Service Bulletin

Faulty Door Sensor Setup Leading to Charging Disruptions

Power Link 1000

Bulletin Published: December, 2025

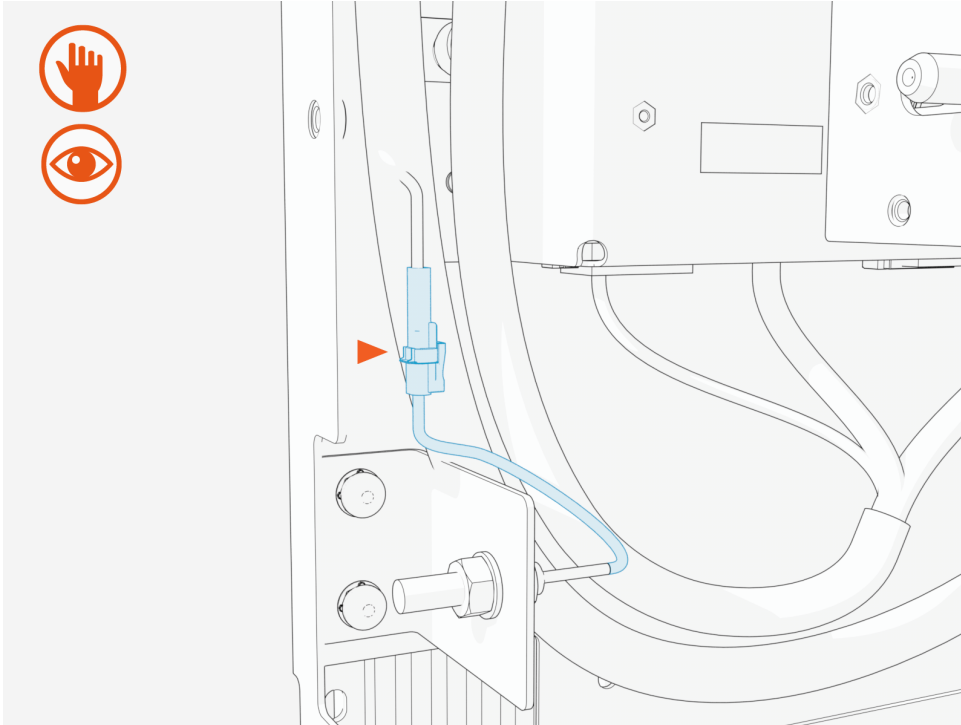
1. Make sure the magnet and sensor are aligned in the correct orientation, refer to the following image.

- (a) **Incorrect:** The potting side of the magnet faces the threaded side of the sensor.
- (b) **Incorrect:** The magnet and sensor are misaligned, their threaded ends do not face each other.
- (c) **Correct:** The threaded side of the magnet and the threaded side of the sensor face each other and are properly aligned.

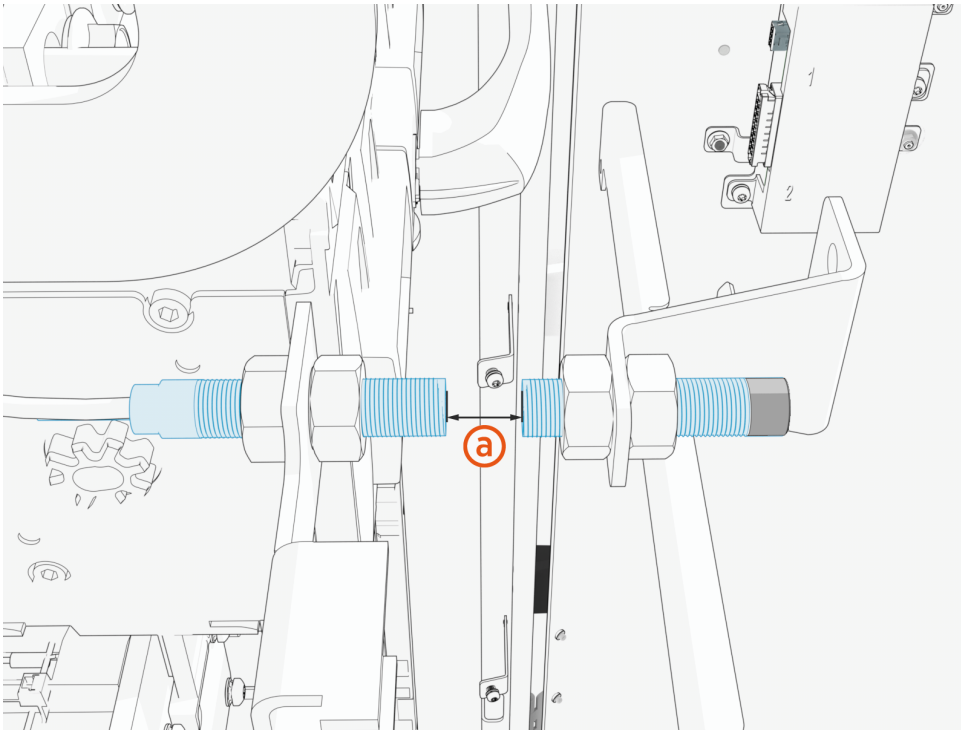
-
2. Inspect the Molex connector for bent pins, corrosion, or loose fit.

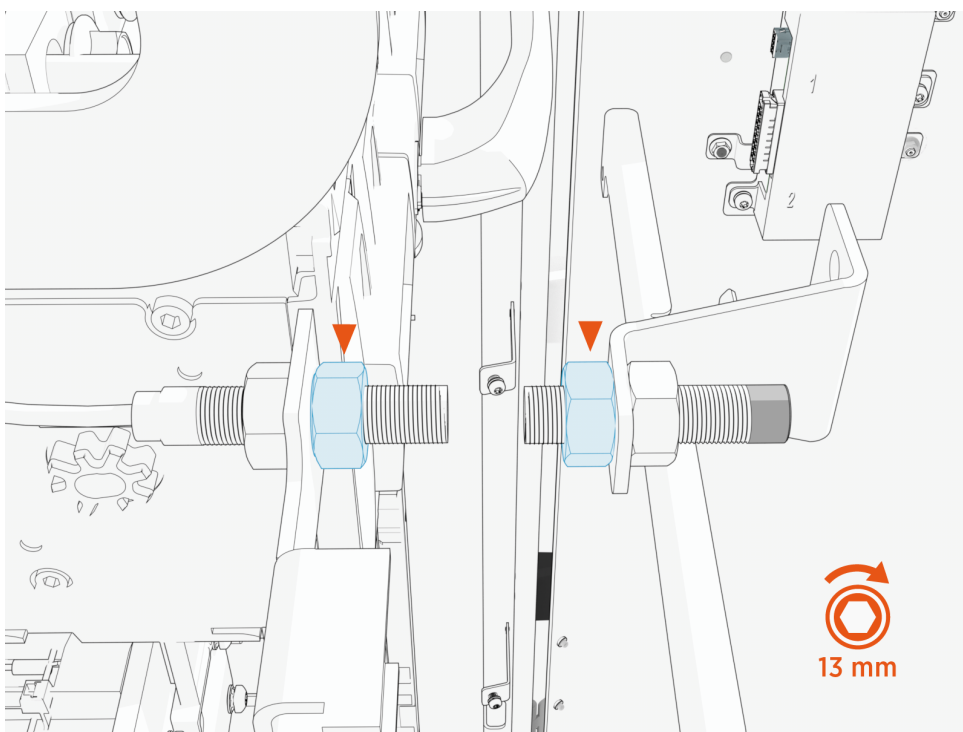
- Check that all conditions listed in the [Troubleshooting](#) section are met before proceeding to torque the nuts.
- Use the 13 mm socket, torque the nuts to **1.13 Nm (10 in-lb)**.
